Body Repair News

MODEL/YEAR MODÈLE /ANNÉE	DATE OF ISSUE DATE EN VIGUEUR	BULLETIN NUMBER NUMÉRO DU BULLETIN
ALL MODELS	JULY 8, 2014	BRN-14-7
Rev. January 4, 2018: Revisions, new information

Body Repair Manual Welding & Sectioning Guideline Revisions

Rear Inner Panel Service Part Example

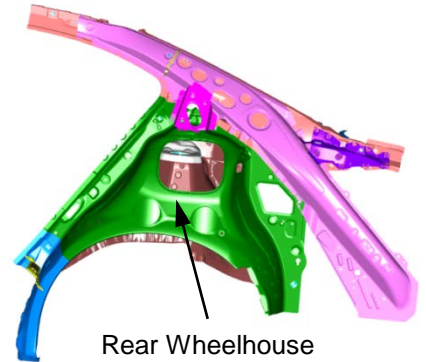
- Replacement of body service parts as supplied at factory seams is the preferred repair method, except when it may cause unnecessary or excessive intrusion into the body structure.
- In these cases, the service part may be disassembled at factory seams as required to replace only the damaged portion.
- For example, if only the vehicle's rear wheelhouse is damaged, that part may be removed from the rear inner panel service part assembly at the factory seams and installed on the vehicle.
- Note that there is **not** a BRM replacement procedure for rear inner panels because they are rarely installed as a complete unit.
- All basic welding & sectioning guidelines specified in the service information **must** be observed during partial panel replacement.

Sectioning Area Examples

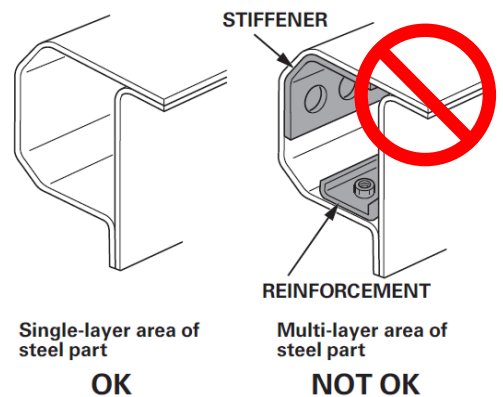
- Outer body and floor panels may be sectioned as necessary. Specific sectioning procedures are not provided in the BRM.
- Depending on the type of vehicle damage, steel parts with a tensile strength of 780 MPa or less may be sectioned **if all three of the following conditions are met:**

1. Sectioning must be done in a single-layer area of the part.
 2. Multi-layer internal steel reinforcements and stiffeners must not be cut.
 3. Do not section in load bearing areas, such as engine, transmission, or suspension mounting points.
